# Access Compliance Report

## Public Rights-of-Way

Intersection ID: 5823	Main Street: FOSTER_BROOK_DR	Cross Street: HIPPI_RD	Location:	N/A
ADA ID: 40ADDC4DB9C5	Ramp Type: BlendTrans2	Initial Pass/Fail: Fail	Overall Compliance: No	Severity Score: 35
Codes/Mitigation Info/Possible Solution		Field Measurements/Component Compliance

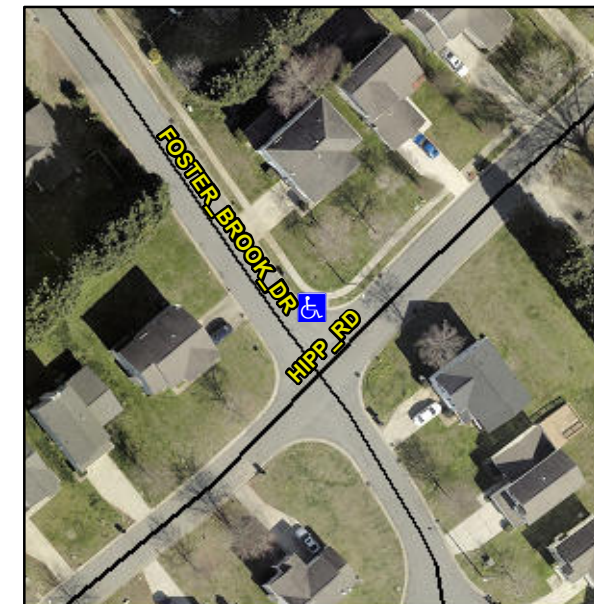
**Remove & Replace Curb Ramp With Two New Directional Ramps or Equivalent.**

**Not Found, R304.5.1**
